Review of the Pump-and-Treat Improvement Initiative Report and Plume Containment and Remediation Utilization Plan and Associated Recommendations

Communication to DOE/RL

August 10, 2017

This document is prepared by PNNL and SRNL and provides comments and suggestions on the CHPRC documents, “Pump-and-Treat (P&T) Improvement Initiative (well-fouling) report (PTII, SGW-60832, Draft, June 2017) and the 2018 Plume Containment and Remediation Utilization Plan (PCRUP, SGW-60843, Draft, June 2017). The CHPRC documents identify actions to improve the operations of the 200 West Pump and Treat System and reduce the observed injection well fouling issues. The main components of the 200 West Pump and Treat System addressed in the CHPRC report are the Fluidized Bed Reactors (FBRs), Membrane Bio-Reactors (MBRs), Air Stripper System (A/S), Well-Field Conveyance System for Treated Effluent (effluent system), and the Injection Wells.

Figure 1. Example depiction of the components of P&T system operational and mitigation actions to address well-fouling issues.

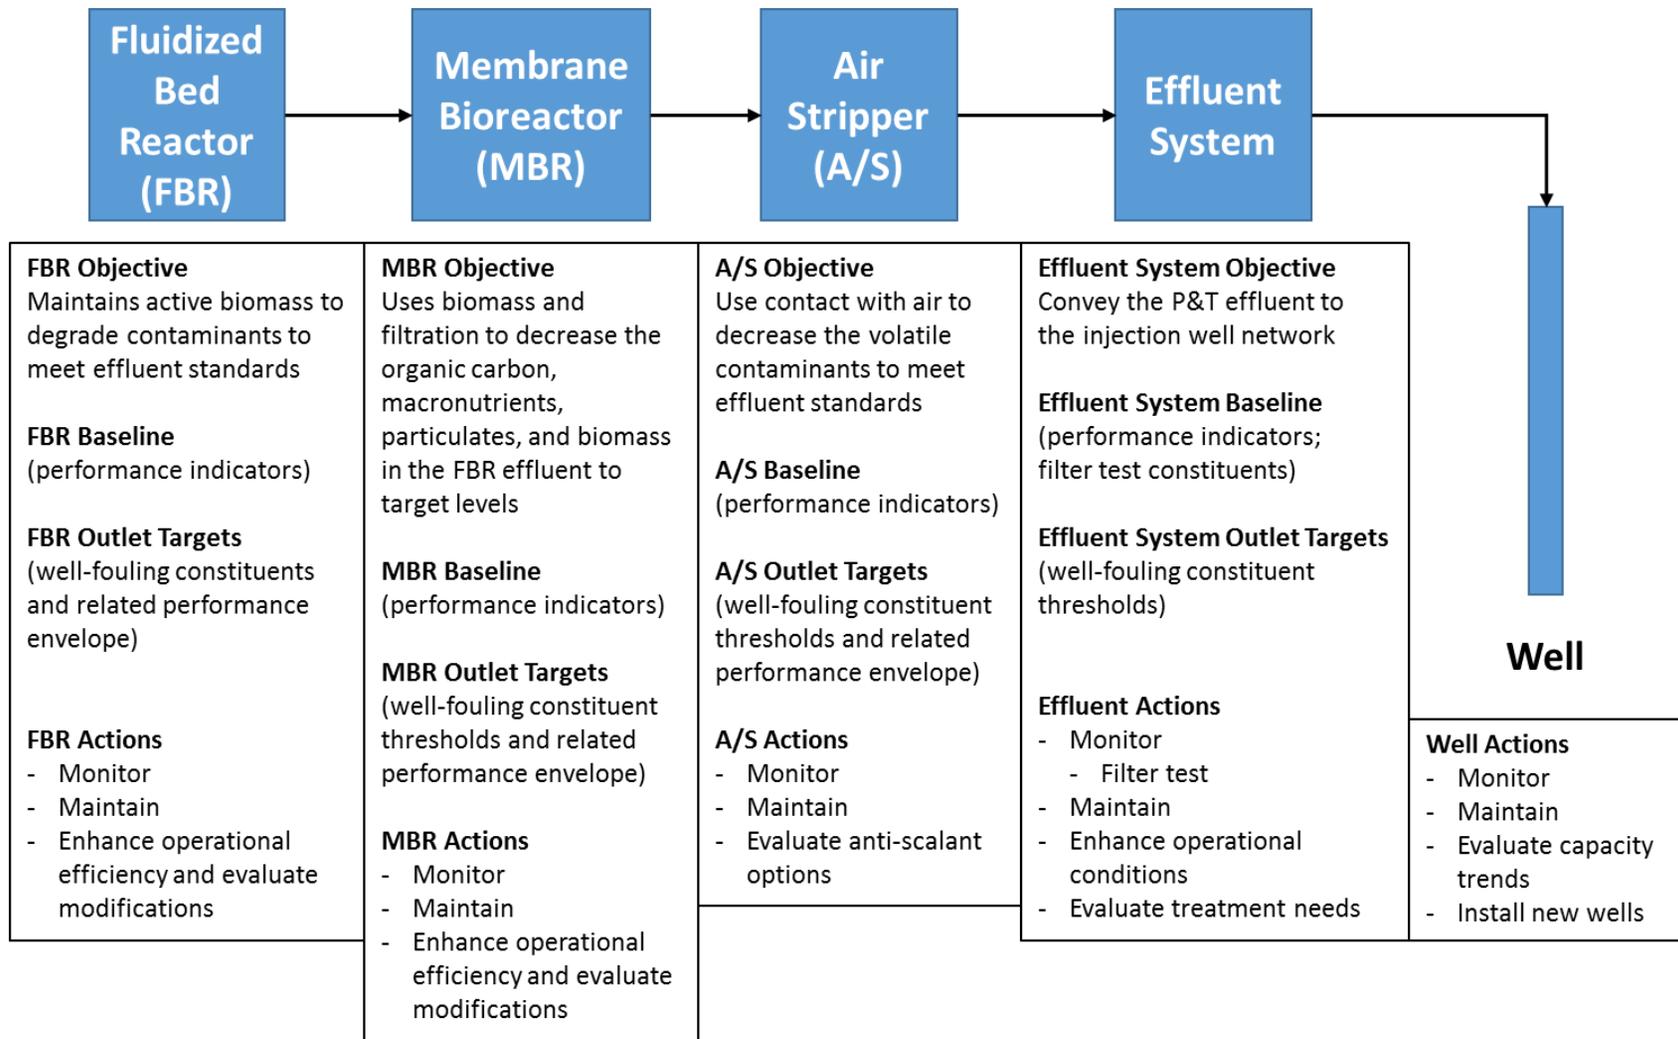
To facilitate robust operation of the 200W P&T system, the review team recommends that actions associated with mitigating well-fouling issues be organized as shown in Figure 1. Operational and mitigation actions have been identified for the Fluidized Bed Reactor (FBR), Membrane Biofilter Reactor (MBR), Air Stripper (A/S), effluent system, and injection wells associated with addressing the current well-fouling issue. To organize and manage implementation of these actions, the review team recommends compiling baseline information for the influent and effluent water chemistry and operational parameters of each unit operation. We recommend establishing target values (or ranges) for these measured constituents that lead to conditions that will meet the goals for sustainable injection operations. As changes are made, monitoring of progress toward these targets can provide feedback to decisions about any additional changes that are needed. It is recognized that the targets may need to be adjusted as information is obtained over time about how these values relate to injection well performance. The review team recognizes that along with the technical evaluations described herein, there are also monitoring and maintenance categories of actions that need to be managed in conjunction with mitigation actions.

Figure 3. Example configuration showing disinfectant addition before the air stripper

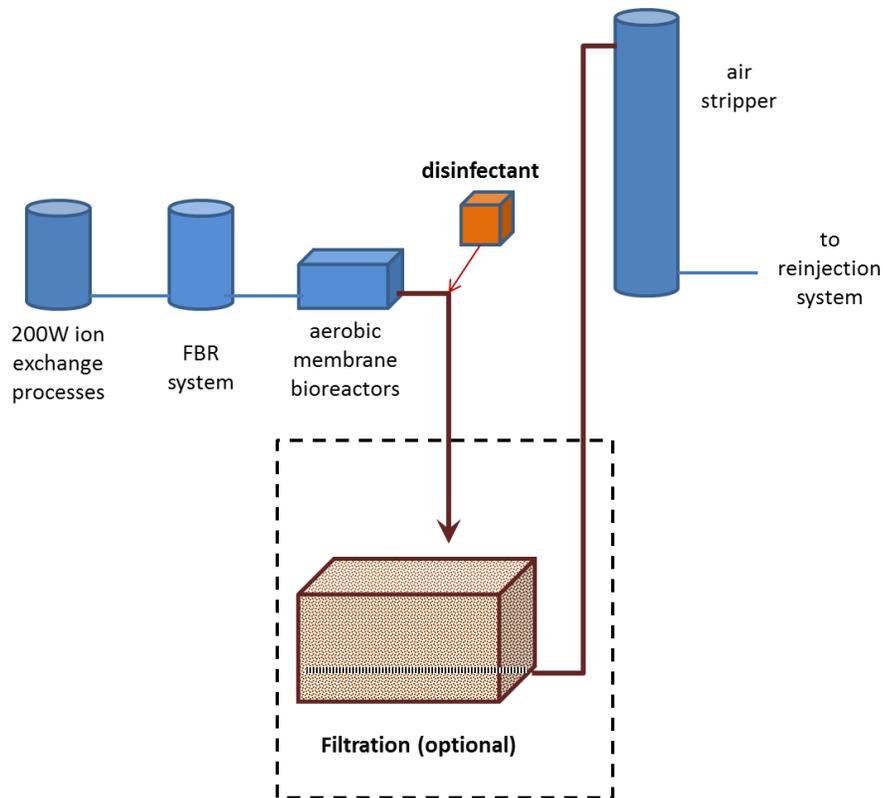
Notably, there may be substantive advantages associated with adding the disinfectant before the air stripper (i.e., minimizing biofilm growth and/or scaling in the air stripper) – this type of disinfectant-related reconfiguration was not identified in the PTII report and is of potentially significant impact (Figure 3). If disinfection were added before the air stripper it might provide a secondary benefit of altering the need for antiscalant. Any disinfection system will impact the geochemistry of the effluent (by raising the redox potential to 600 or 700 mv) and result in precipitation of some elements such as iron and manganese. As a collateral benefit of pre-stripper disinfection, with the addition of a simple sand filter, the precipitation/removal of these metals has the potential to reduce mineral fouling in the reinjection well screens and reduce/eliminate the need for antiscalant in the air stripper.
